MARTHA'S VINEYARD COMMISSION P.0.BOX 1447 • 33 NEW YORK AVENUE • 0AK BLUFFS • MA • 02557 508.693.3453 • FAX: 508.693 7894 • INFO@MVCOMMISSION.ORG • WWW.MVCOMMISSION.ORG DRI 633 - Oak Bluffs Roundabout Bus Stops and Associated Walkways

January 28, 2012

This technical memo prepared by MVC staff addresses the proposed bus stops at the Oak Bluffs Roundabout, for use by the Commission in evaluating the location of stops, the use of pullouts, and other related issues it had conditioned related to bus stops as part of its DRI approval.

Original MassDOT proposal

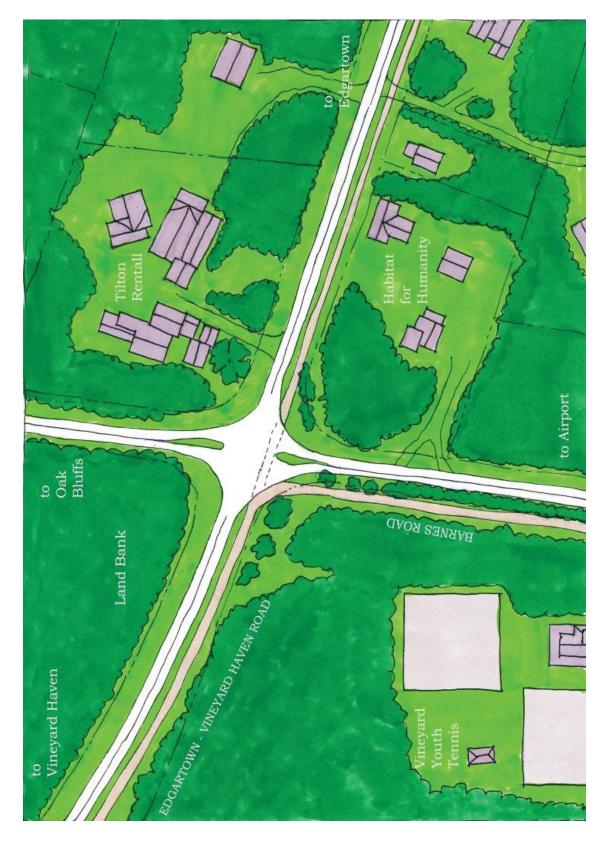
If the buses stop in the travel lane, the platforms can be reduced to the minimum 10' required by ADA, since the bus can pull up so either the front or the rear door aligns with the platform. If a pullout is provided that is the length of a bus, the platform has to extend from the front of the front door to the back of the back door of the largest bus, namely about 30 feet. Note that in the original plans reviewed by the Commission, the platforms were 60 to 80 feet long.

During the review of the roundabout, several Commissioners raised the following concerns about providing bus pullouts (referring to the plan being reviewed at that time).

- They would add to the paved area of the roundabout project and the project's overall visual impact.
- They would lead to the removal of a large number of mature trees and potentially eliminate the canopy of trees that now exists over the section of Barnes Road south of the intersection.
- This is and is likely to remain a rural area with little pedestrian traffic and few people boarding or alighting buses.²
- They add to the cost of the project.
- There has been no community consensus about the desirability of providing bus pullouts across the Island. To do so would have a negative impact on the character of the Island's rural roads. If they are to be provided, they should only be in locations of greatest need, and it is not clear that this area would qualify.

If some or all four pullouts are installed, they would have less impact than the bus pullouts in the proposal originally submitted to the Commission:

- There would be four rather than six,
- They would be shorter about 40' long rather than 60 to 80 feet long (plus angled entries/exits),
- They would be located where there would be relatively little impact on trees,
- They would be staggered with only one in each stretch of roadway.
- They would be treated with special materials to contrast with the roadway, rather than as an asphalt extension of the roadway.
